Meeting Date: Tuesday 3 April 2012
Location: Committee Room 2, Level 5, Civic Centre, 1 Devlin Street, Ryde
Time: 4.00pm

Planning and Environment Committee
MINUTES OF MEETING NO. 3/12

**3 51-75 BUFFALO ROAD & 43A HIGGINBOTHAM ROAD, GLADESVILLE.
LOT 12 DP83596. Section 96 application under the Environmental
Planning & Assessment Act, 1979, to amend the secondary access
arrangements to the Ryde Bus Depot. LDA2006/335 / MOD2011/143.**

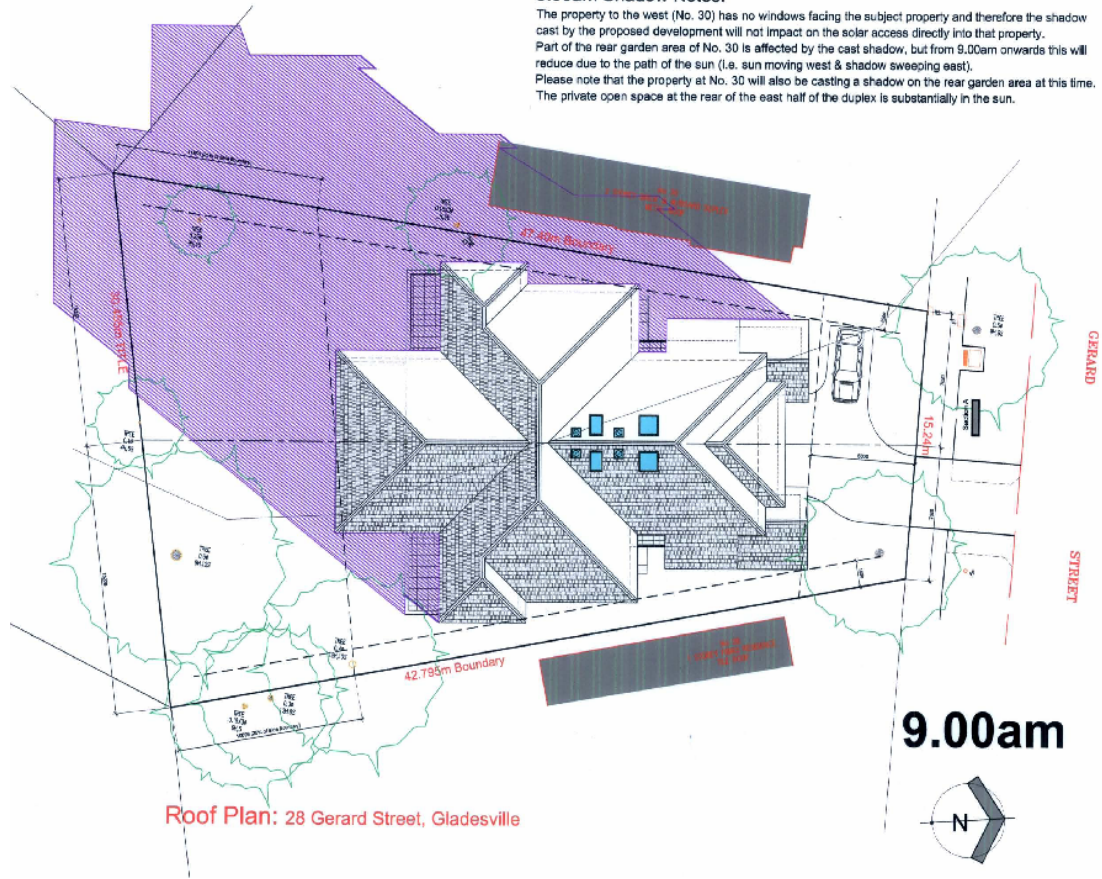
Comment: The submitted Shadow Drawings show, in respect of No. 26 Gerard Street, that the likely shadow impact from the proposed development will not impact upon No. 26 Gerard Street until approximately 1.00pm at mid-winter, and after this time the shadow will impact firstly on the private open space area and then the dwelling. The living rooms in No. 26 Gerard Street are not likely to be impacted upon by mid-winter shadows until approximately 1.30pm. At this time No. 26 Gerard Street would have enjoyed at least 4.0 to 4.5 hours of mid-winter solar access. This exceeds the DCP requirement.

12.00 noon Shadow Notes:

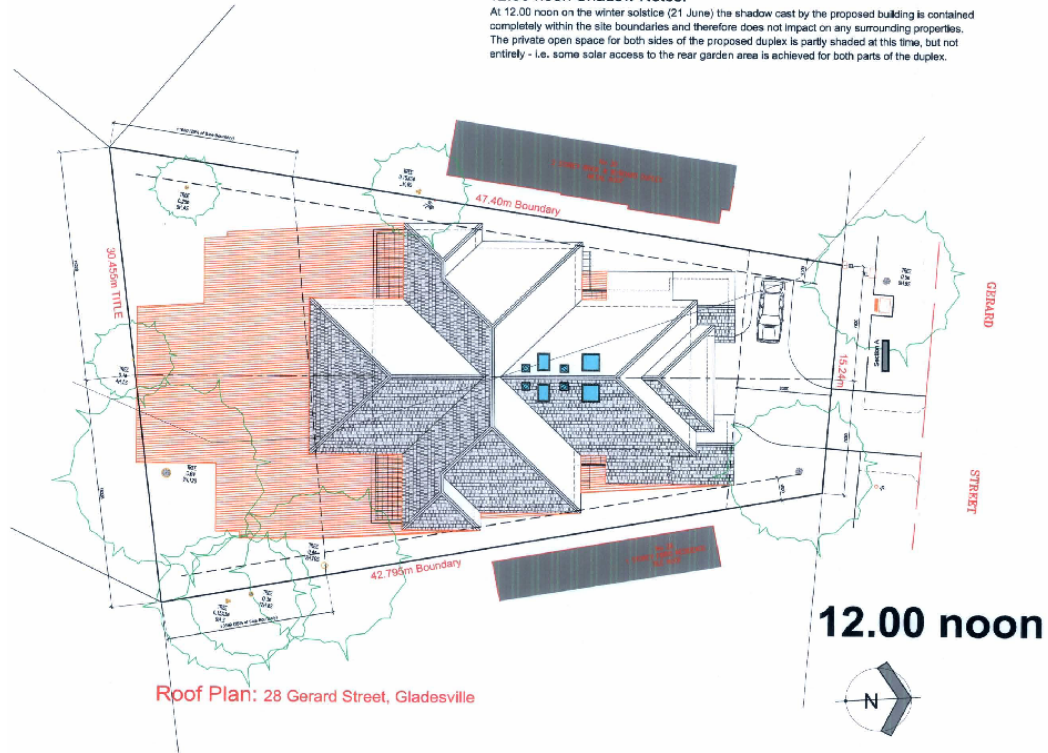
At 12.00 noon on the winter solstice (21 June) the shadow cast by the proposed building is contained completely within the site boundaries and therefore does not impact on any surrounding properties. The private open space for both sides of the proposed duplex is partly shaded at this time, but not entirely - i.e. some solar access to the rear garden area is achieved for both parts of the duplex.

The following aerial photograph of No. 30 Gerard Street clearly shows the location of the central courtyard.

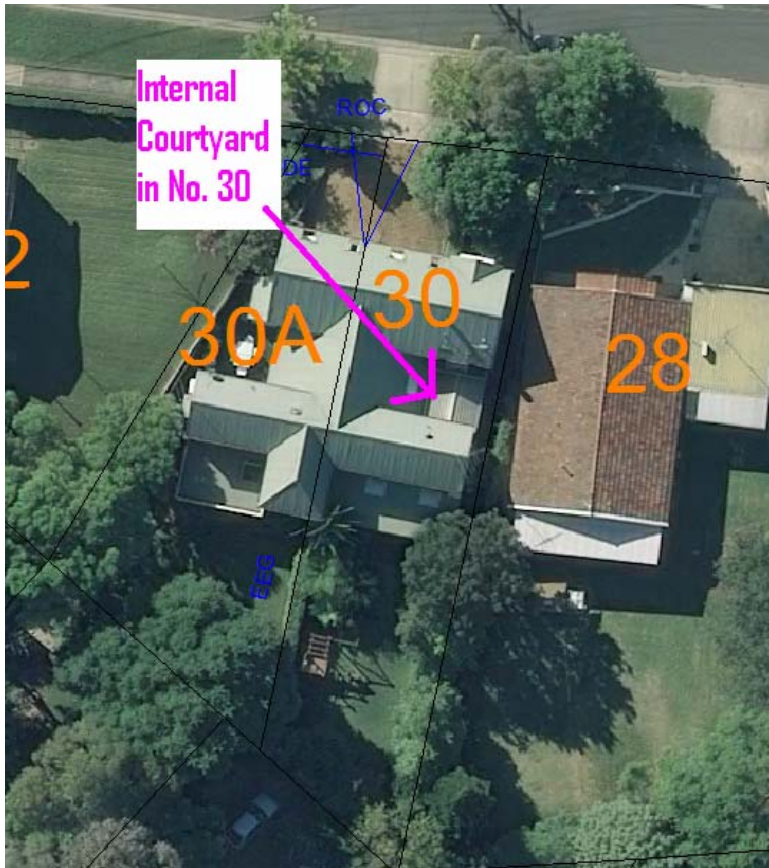
It is acknowledged that the DCP does not address the unusual situations of mid-building courtyards as exists in No. 30 Gerard Street. However, as suggested in the submission from No. 30 Gerard Street, the only identifiable answer is to reduce the front of the proposed development to single storey, which is unreasonable and inequitable given that the DCP allows 2 storey developments.

The following is the rear (south) elevation drawing, showing the height and extent of the fill proposed, which is at the highest at the south-west corner of the development:

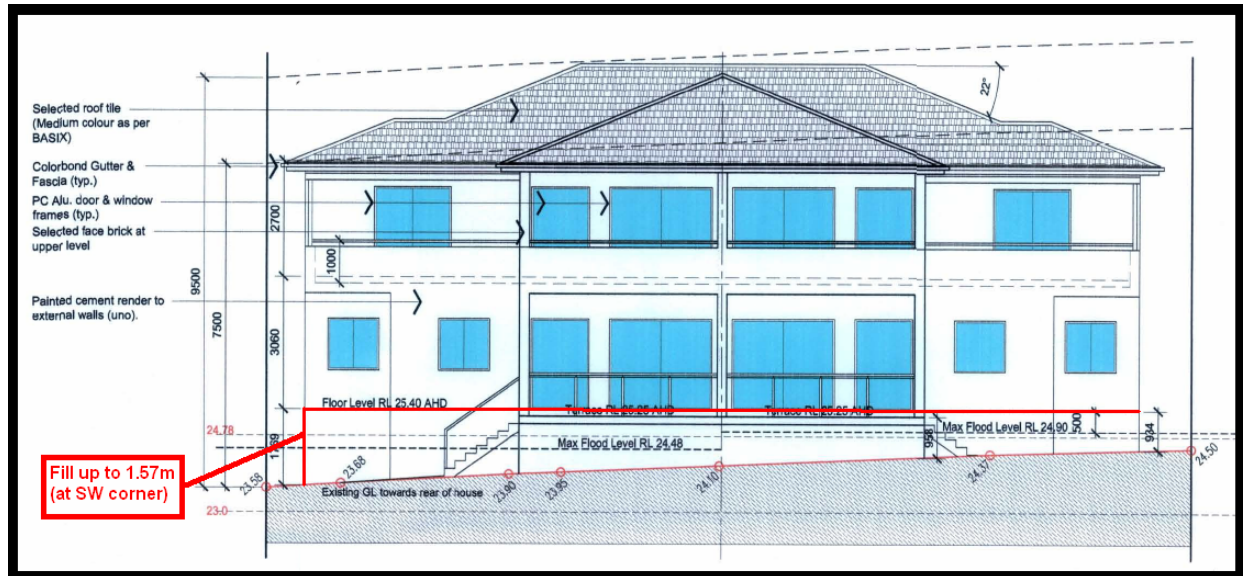
The proposal involves up to 1.57m of fill under the rear of the western dwelling. This is generally the lowest portion of the site, and requires the floor level of the ground floor to be RL 25.40 to achieve the required 500mm of freeboard above the overland flow level. The natural ground level in this area is RL23.83 and it requires 1.57m of fill to achieve the ground floor level of 25.40. In view of the limited area of fill, and the engineering necessity for the fill, the proposal is considered to be reasonable.

The small section that is less than the required 6.0m is shown by yellow colour in the following diagram:

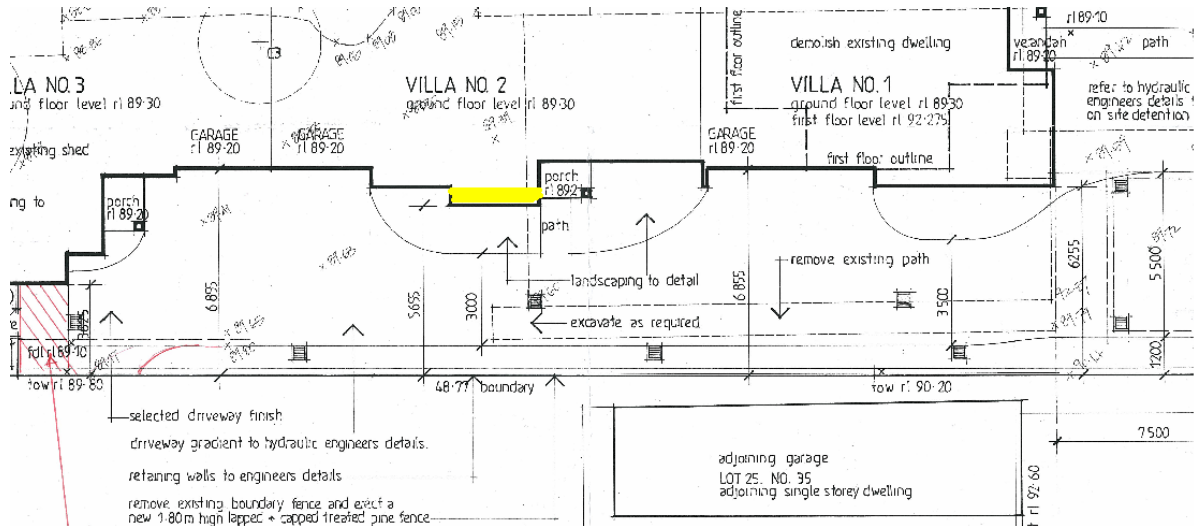
The only departure from the DCP standard is where the driveway is proposed along the eastern side boundary. The proposed setback is mostly a minimum of 6.25m which complies with the minimum of 6.0m as contained in the DCP. However, one small section of Dwelling 2 is setback 5.65m from the side boundary.

Given that the portion of the driveway that is less than 6.0m wide is quite short, and is not likely to adversely affect the functionality of the overall driveway, amending the design of the building so as to achieve the 6.0m driveway width is considered not necessary.

The proposed rear boundary setback is, as shown on the following diagram, between 3.06m and 4.5m.

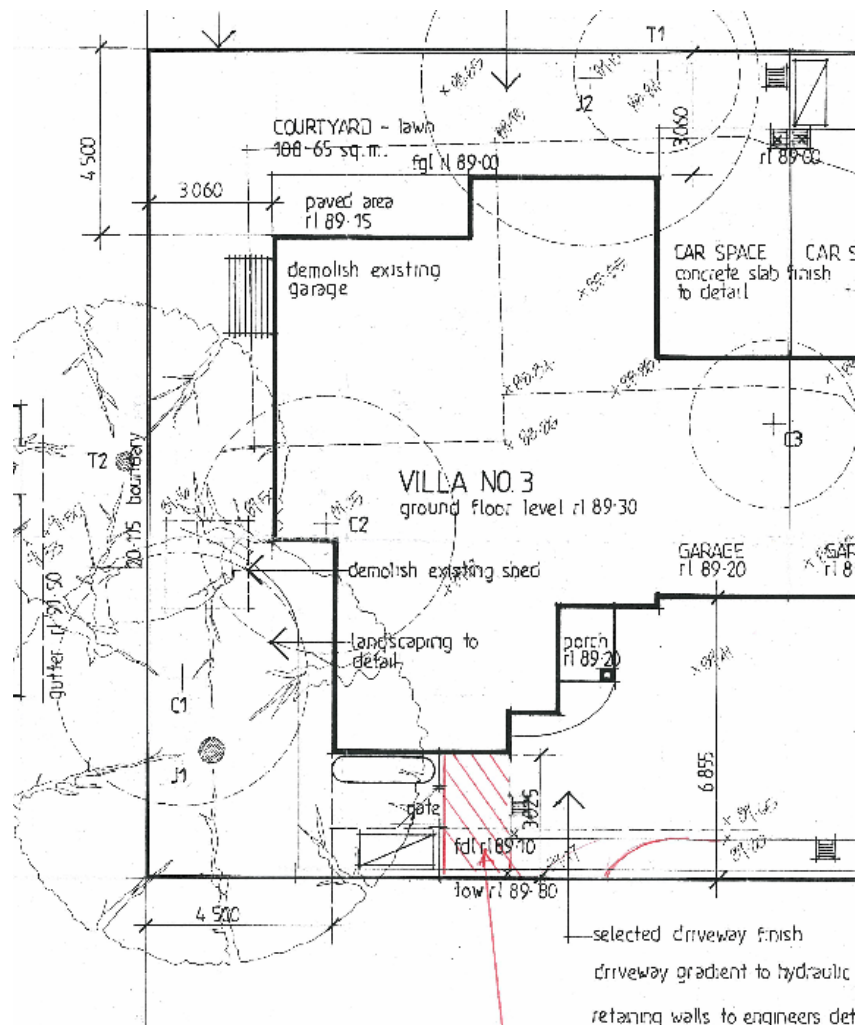
The DCP control permits a maximum 50% of the rear boundary setback to be between 3.0m and 4.5m. However, 59.4% of the setback is between 3.0m and 4.5m. The degree of design modification required to achieve compliance with the DCP control is small, but from a practical point of view would have no identifiable change to the visual impact of the rear elevation, and may affect the functionality of Villa 3. Accordingly, it is recommended that this minor departure from the DCP controls be accepted.

A small section that is less than the required 6.0m is shown by yellow colour in the following diagram:

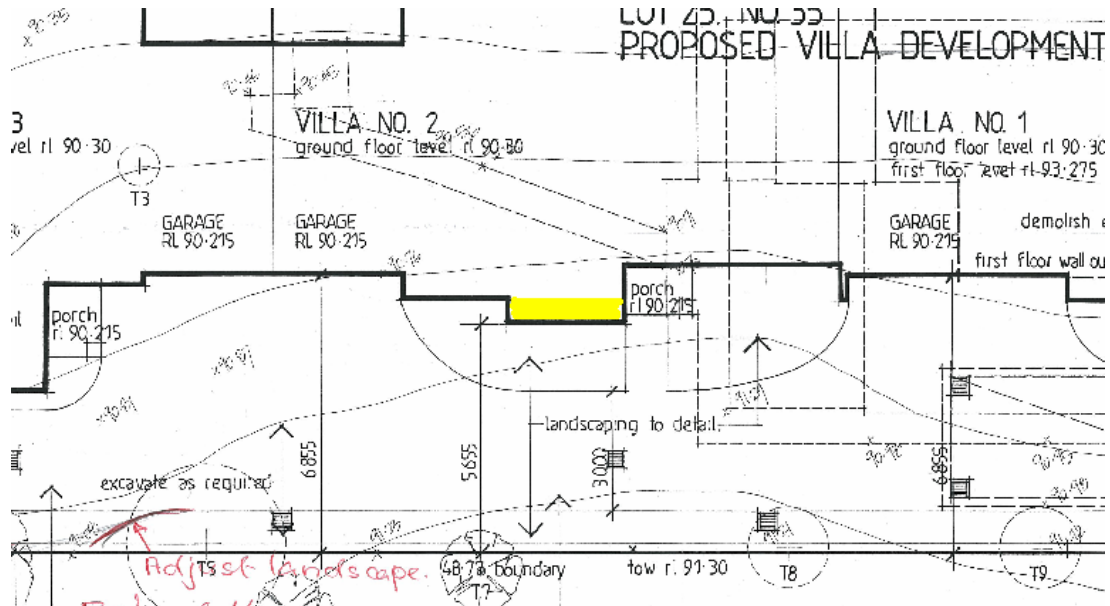
The only departure from the DCP standard is where the driveway is proposed along the eastern side boundary. The proposed setback is mostly a minimum of 6.25m which complies with the minimum of 6.0m as contained in the DCP. However, one small section of Dwelling 2 is set back 5.65m from the side boundary.

Given that the portion of the driveway that is less than 6.0m wide is quite short, and is not likely to adversely affect the functionality of the overall driveway, amending the design of the building so as to achieve the 6.0m driveway width is considered not necessary.

The proposed rear boundary setback, as shown on the following diagram is between 3.06m and 4.5m.

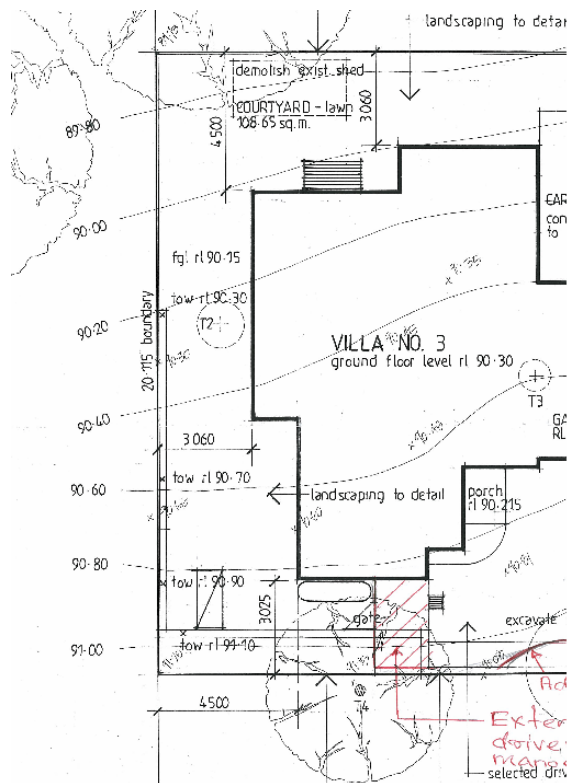
The DCP control permits a maximum 50% of the rear boundary setback to be between 3.0m and 4.5m. However, 59.4% of the setback is between 3.0m and 4.5m. The degree of design modification required to achieve compliance with the DCP control is small, but from a practical point of view would have no identifiable change to the visual impact of the rear elevation, and may affect the functionality of Villa 3. Accordingly, it is recommended that this minor departure from the DCP controls be accepted.
